**HILLSBOROUGH COUNTY
SOUTHEAST COUNTY LANDFILL
CAPACITY EXPANSION, SECTION 8
CERTIFICATION OF CONSTRUCTION
COMPLETION REPORT
RESPONSE TO DEP REQUEST FOR
ADDITIONAL INFORMATION**

Subject: Response to Request for Additional Information
Southeast County Landfill, Hillsborough County
Capacity Expansion Section 8
Certification of Construction Completion
Permit No. 35453-009-SC
Jones Edmunds Project No. 08449-020-01

**HILLSBOROUGH COUNTY
SOUTHEAST COUNTY LANDFILL
CAPACITY EXPANSION, SECTION 8 CLASS I LANDFILL
CERTIFICATION OF CONSTRUCTION COMPLETION REPORT
RESPONSE TO DEP RAI**

ATTACHMENT R3.c.2
PHOTOGRAPH OF WET DRAINAGE

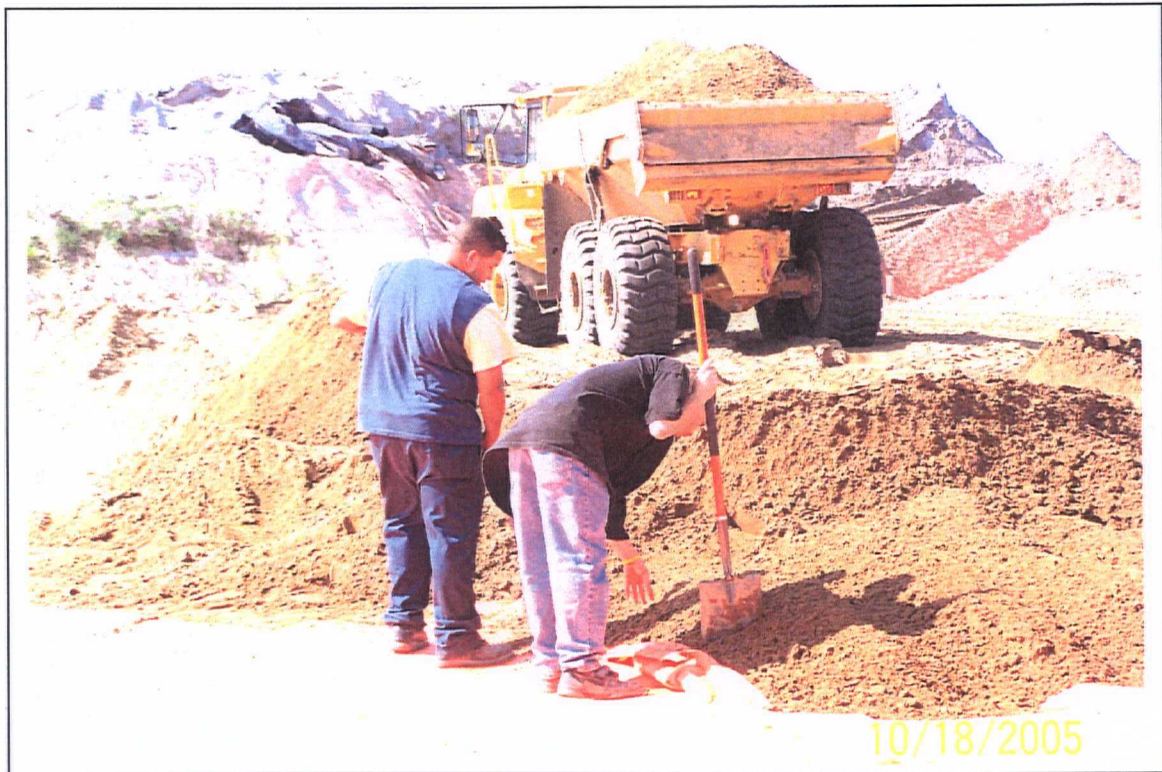
2) 10/08/05. *Please provide photos of the "wet drainage."*

Response 3.c.2): The term "wet drainage" refers to low areas at or near the low points along the south side of Section 8 (sump areas). A photograph showing the wet drainage is included in Attachment R3.c.2.

Response 3.c.2, 10/08/2005 – Southeast County Landfill, Section 8 Capacity Expansion, Hillsborough County, Florida
“Wet Drainage” on top of geocomposite.

ATTACHMENT R3.c.3
PHOTOGRAPH OF SMALL ROCKS AND STICKS

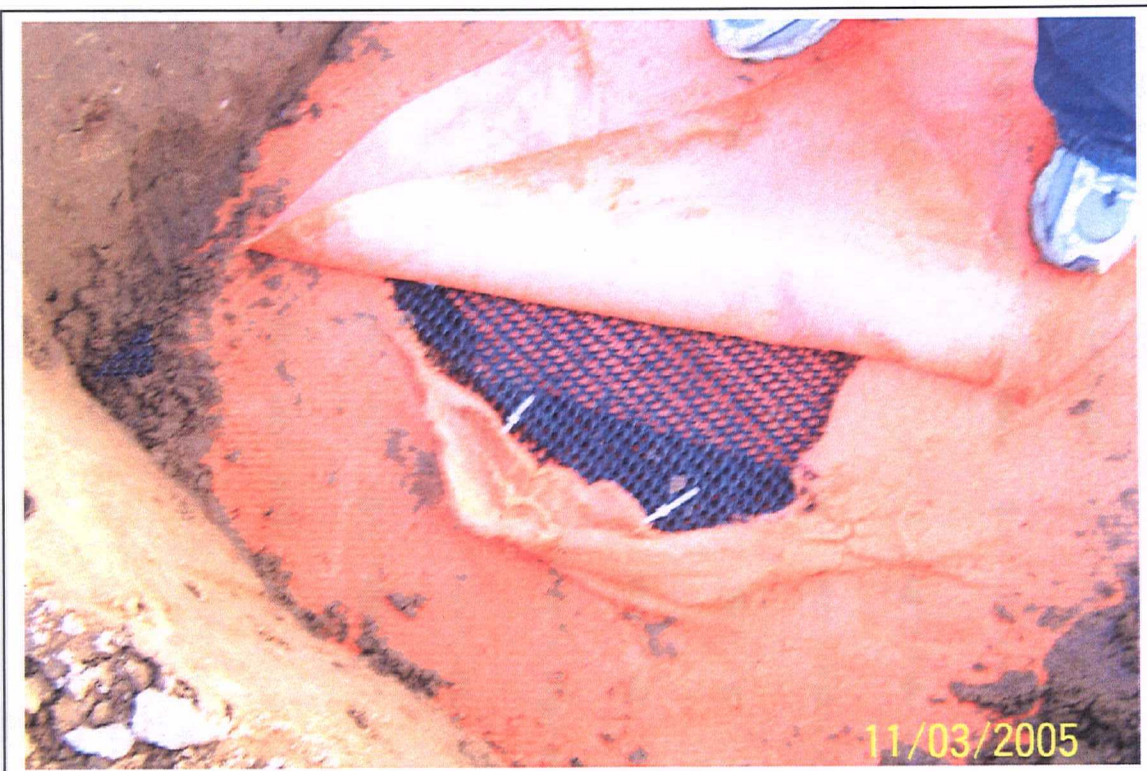
3) 10/18/05, 10/21/05, 10/27/05, 11/11/05. *Please provide photos of the "debris," "sticks, rocks" that were removed from the protective cover soil.*

Response 3.c.3): Small amounts of debris (e.g., sticks and rocks) were sometimes observed in the protective cover soil. The placement of the protective cover soil was closely monitored for such type of "debris" and if observed, was removed from the soil by hand. A photograph showing the small rocks and sticks is included in Attachment R3.c.3.

Response 3.c.3, 10/18/2005 – Southeast County Landfill, Section 8 Capacity Expansion, Hillsborough County, Florida
Workers picking out small amounts of debris from protective cover soil.

ATTACHMENT R3.c.4
REVISED PANEL LAYOUT DRAWING AND
PHOTOGRAPHS

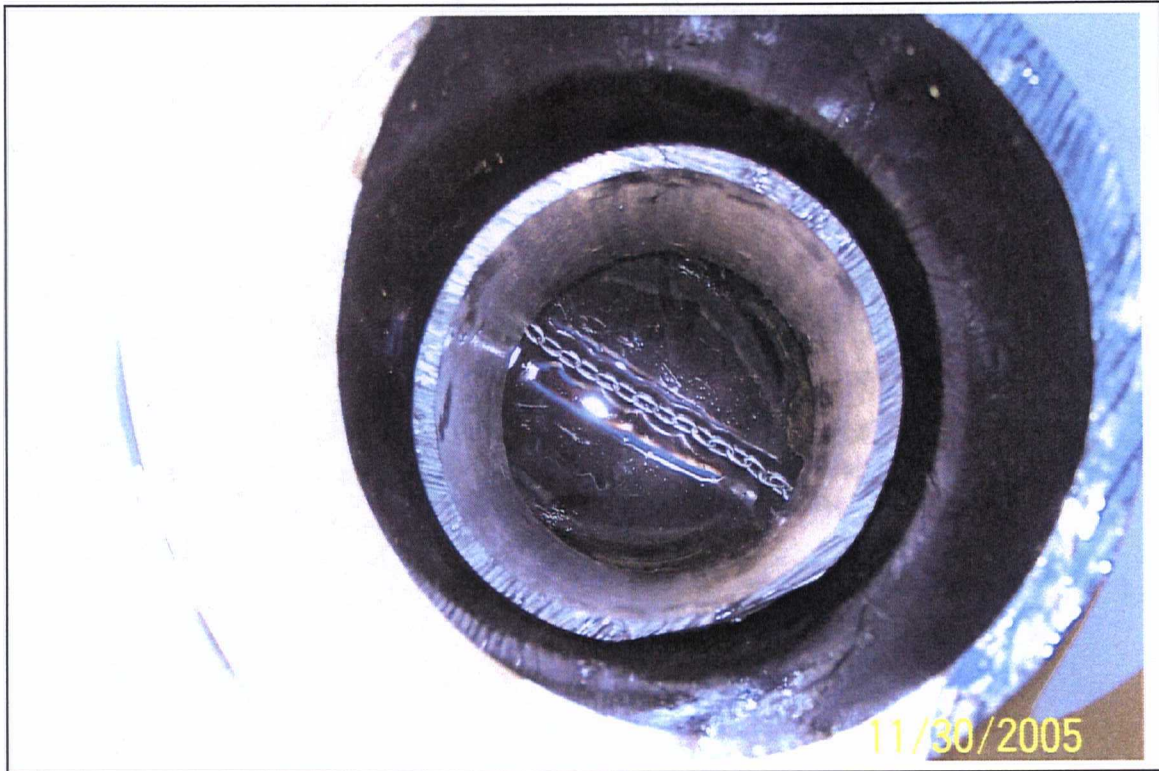
4) 11/3/05. *Please show the location where the "dozer hit geocomposite" on the panel layout drawings. Please provide photos of the damage and repairs.*

Response 3.c.4): The panel layout drawing and testing/repair location drawing as shown in the Jones Edmunds' Report, Section 4, Attachment 4-2 has been revised to

Response 3.c.4, 11/03/2005 – Southeast County Landfill, Section 8 Capacity Expansion, Hillsborough County, Florida
Damage to the geocomposite which was later repaired.

Response 3.c.4, 11/03/2005 – Southeast County Landfill, Section 8 Capacity Expansion, Hillsborough County, Florida
Repaired geocomposite.

ATTACHMENT R3.d.1
REVISED TRI LABORATORY RESULTS
FOR SDT-8C/SDT-26 AND
CORRECTED REPAIR LOG FOR R146

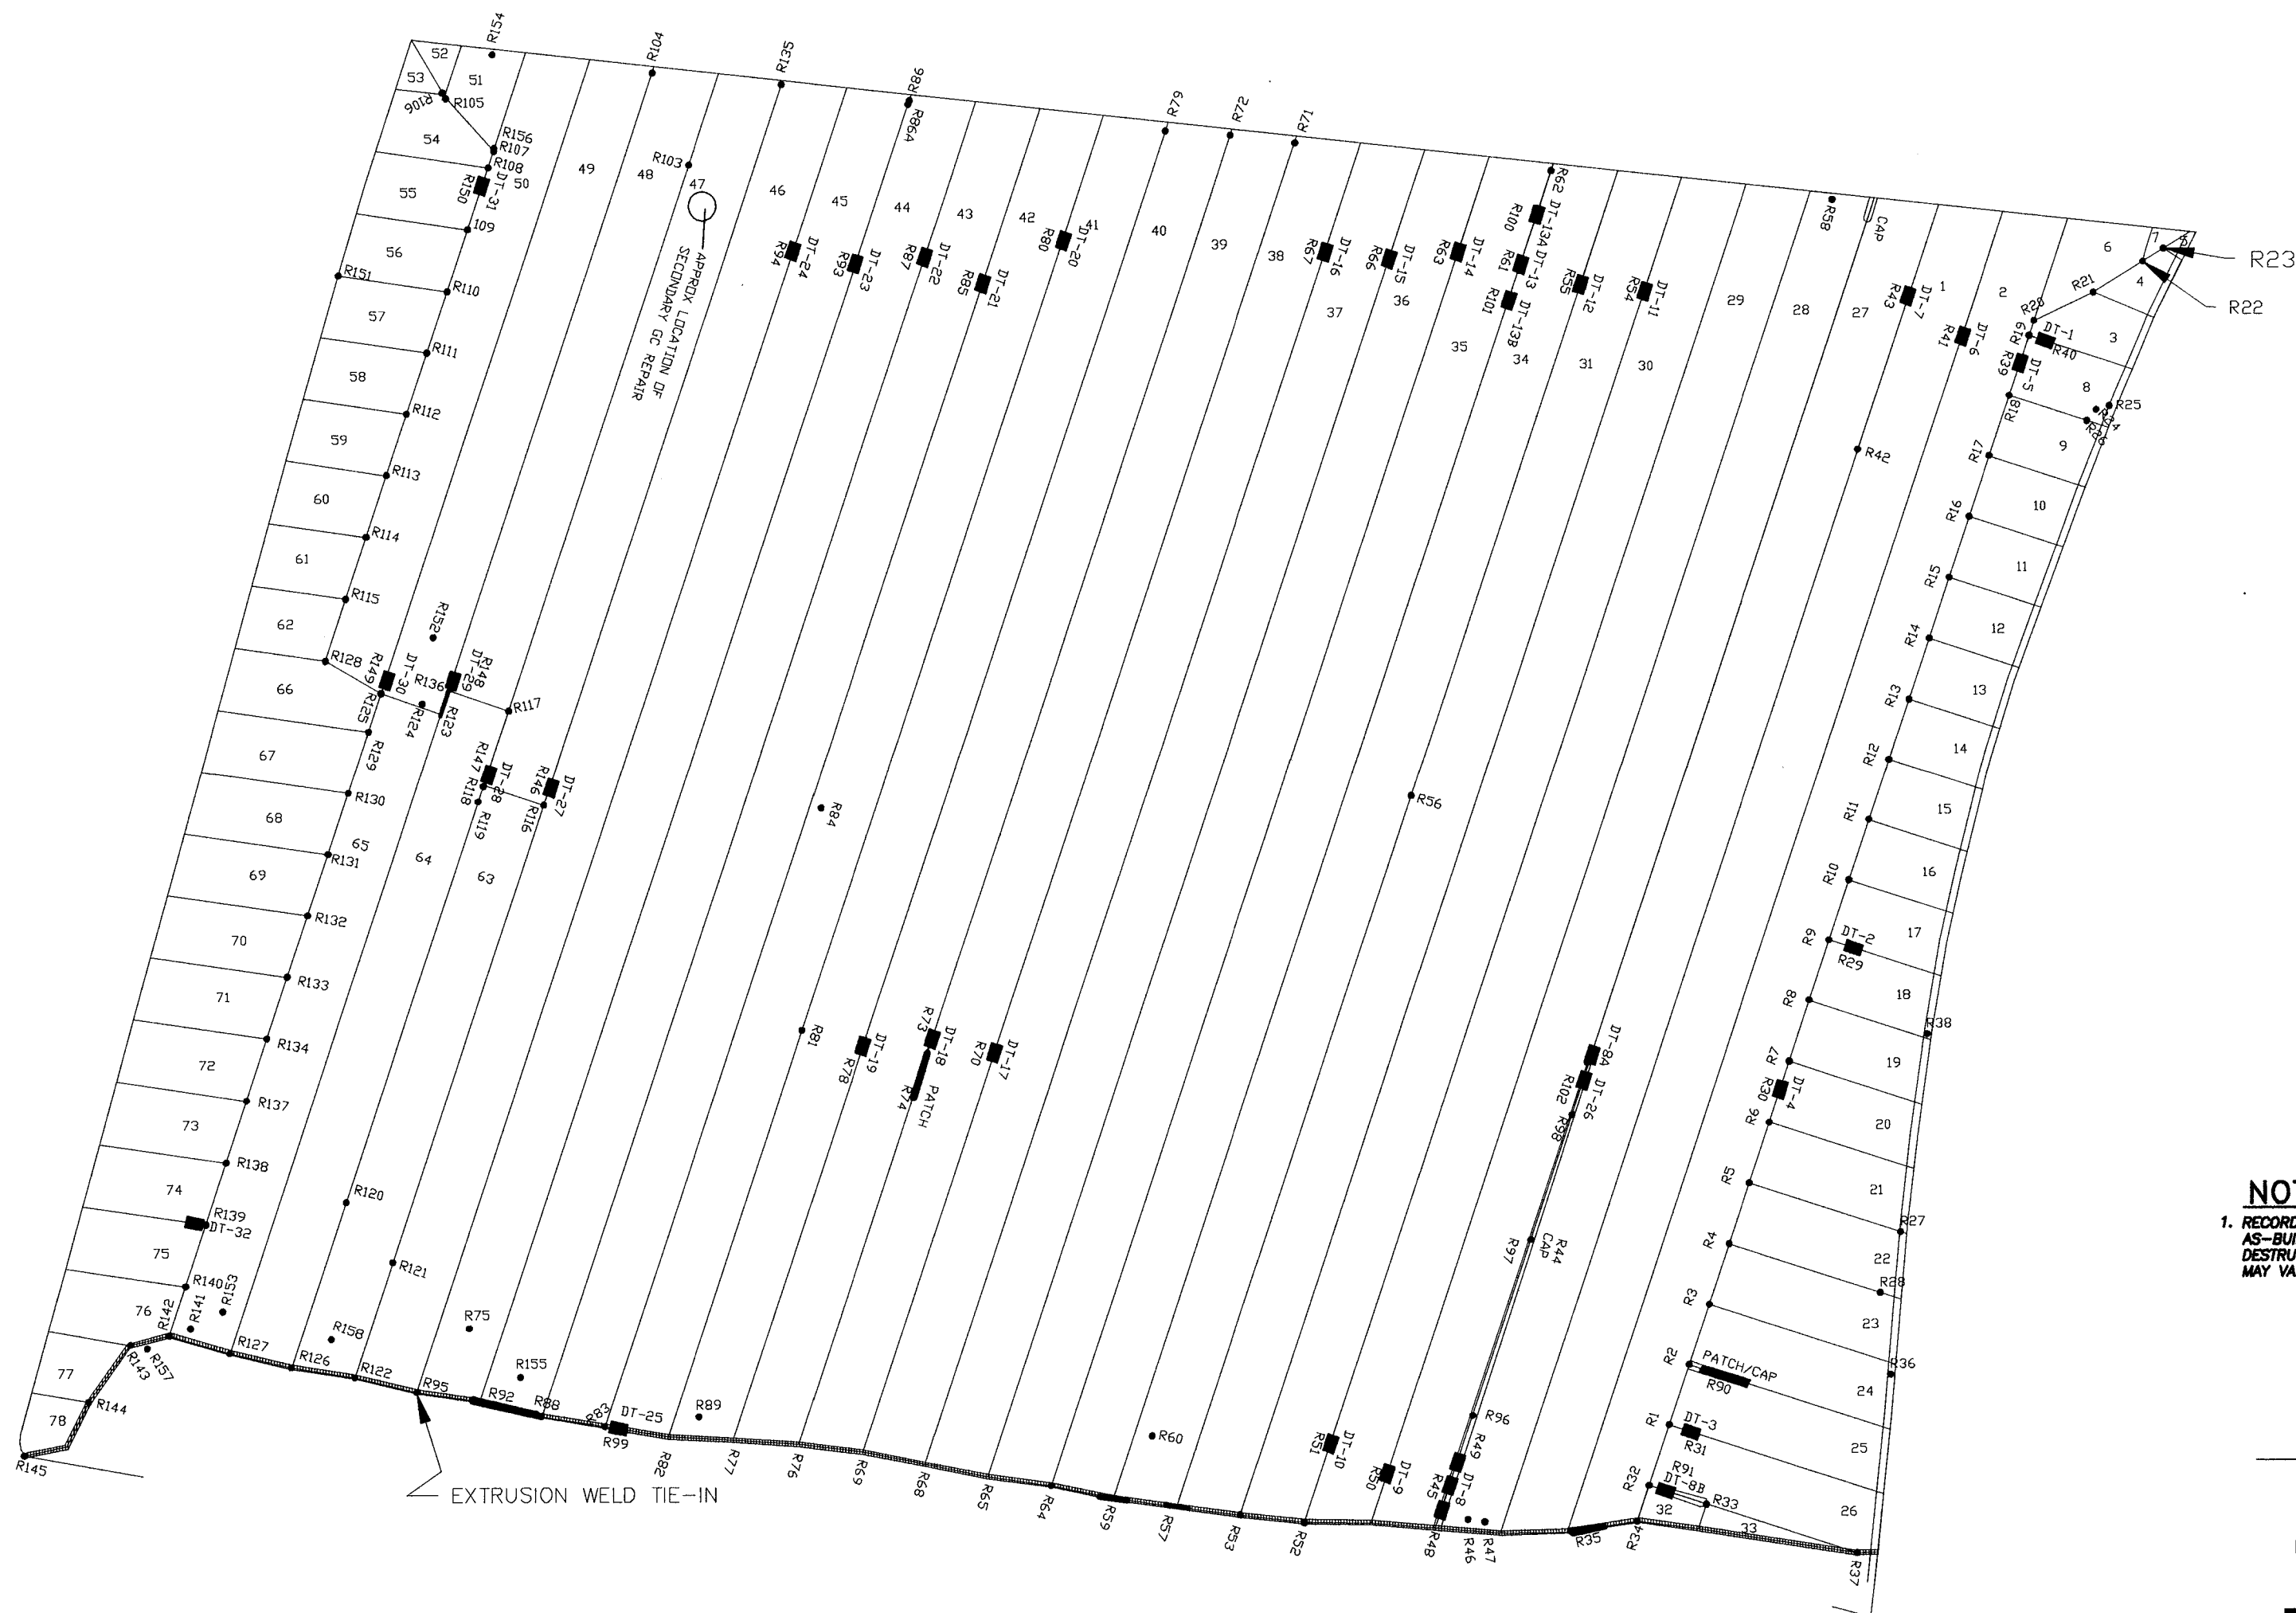
1) Secondary. Please provide a repair number for the "cap" shown on panels 27/28. Please clarify the location of repair R10 (it appears that two R11 were shown). Please note the location of repair R48. Please clarify the location of SDT-8C

(results for this test were provided in Attachment 4-4). Please clarify the location of R48 (the repair log lists the location as 27-28). Please clarify if the cap from DT-8A to R48 was extrusion welded. Please clarify the location of R89 (the repair logs lists the location as 41-Tie). Please clarify the location of R146 (the repair logs list this as 47-48).

SDT-8C failed in the field and was not sent to the laboratory. Therefore there is no TRI laboratory result for SDT-8C. SDT-8A and SDT-8B bound the limits of the portion of the failed seams. SDT-8C was mislabeled in the field and was later corrected to SDT-26. The TRI laboratory test result for SDT-26 is included in the revised TRI test report (see Attachment R3.d.1).

The correct location of R146 is Panel No. 46-47, not 47-48. This page of the Secondary Geomembrane Repair Log has been corrected and included in Attachment R3.d.1.

ATTACHMENT R5.b
SIGNED AND SEALED AS-BUILT SURVEY
FOR PROTECTIVE COVER SOIL

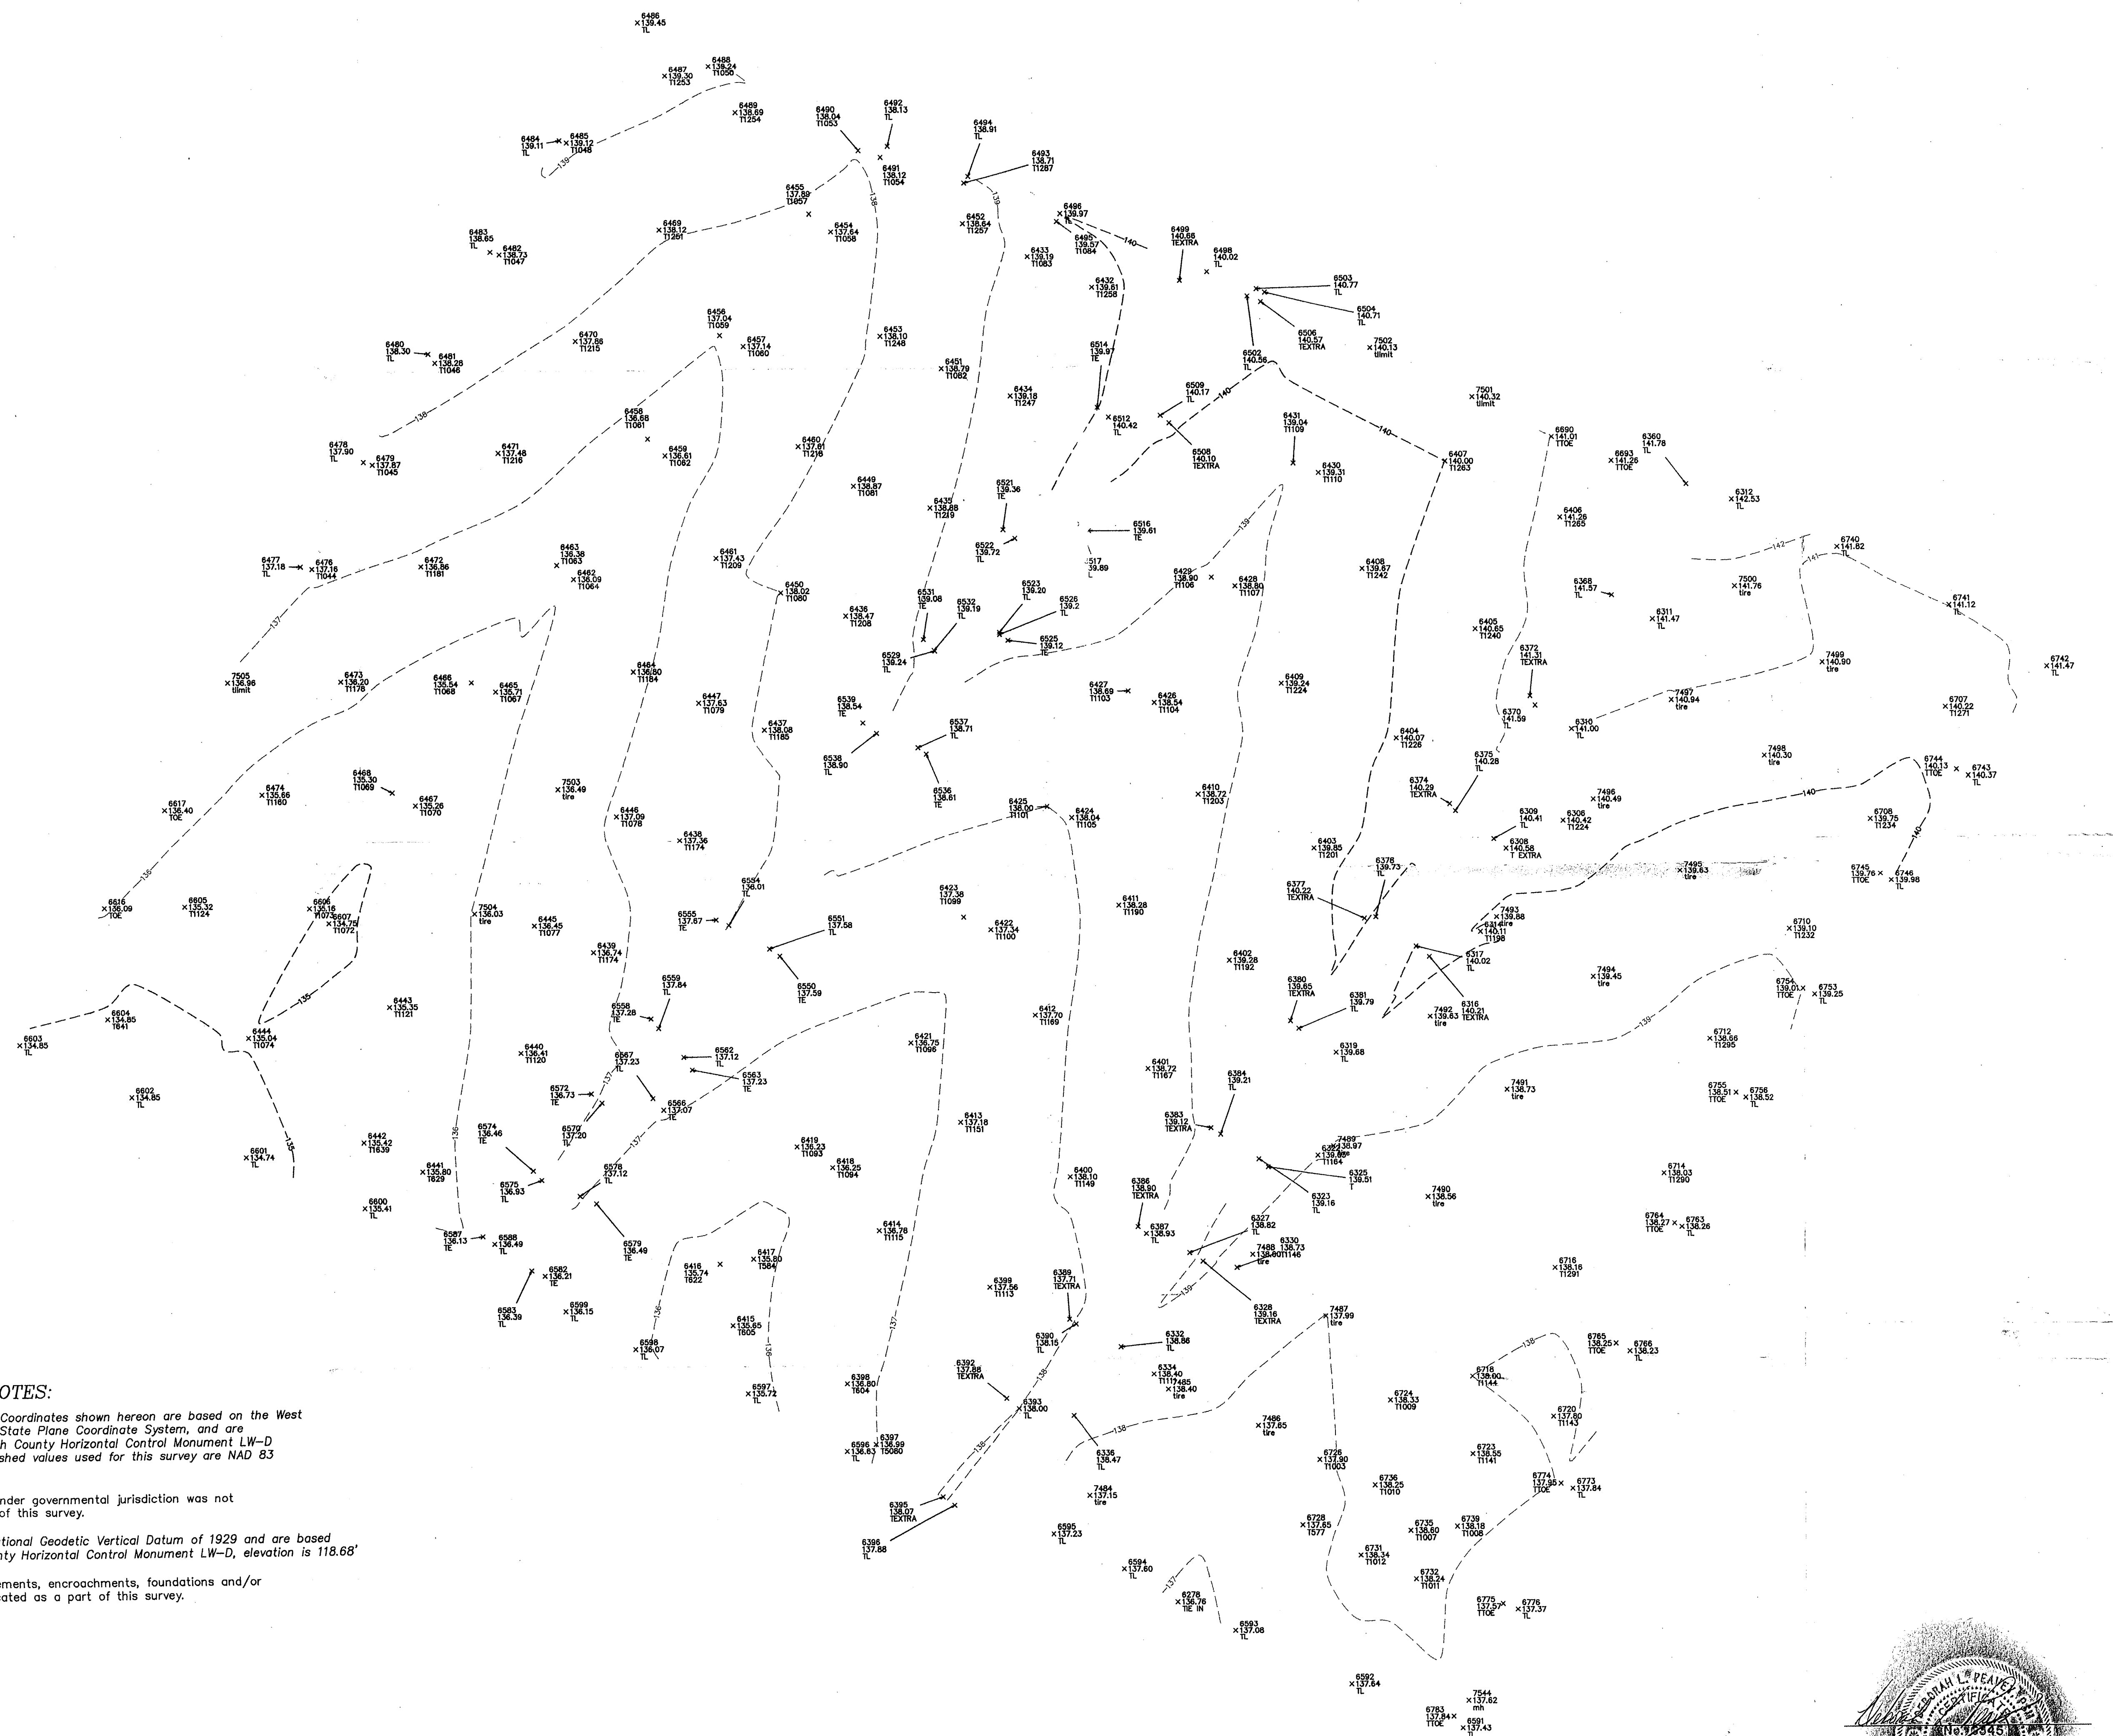
- b. Attachment 6-3, protective cover soil survey. Please provide a signed and sealed as-built protective soil survey. It appears that the locations of the survey points on this survey do not correlate with the survey points on the clay subbase survey (Attachment 3-2) or the tire chip survey (Attachment 7-1) as required by Specification 01050-3.01.C. Please provide surveys that meet this requirement. Based on a comparison of points on the clay subbase survey and the protective soil survey, it appears that in some locations, the protective soil layer did not meet the thickness requirements of Rule 62-701.400(4)(b), F.A.C., and Specific Condition #9.b.*

Response 5.b: A signed and sealed as-built survey for the protective cover soil is provided in Attachment R5.b. Identical points were established on a maximum 50-foot grid on the clay subbase, protective cover soil, and tire chip surveys. The contractor also provided additional points on all three surveys for grade checks. The grid points were compared for construction quality control so that the minimum thickness requirements were met for the clay subbase, protective cover soil, and the tire chips. Jones Edmunds reviewed the grid point elevations and confirmed the minimum required depths for the clay subbase, protective soil cover, and tire chip layers.
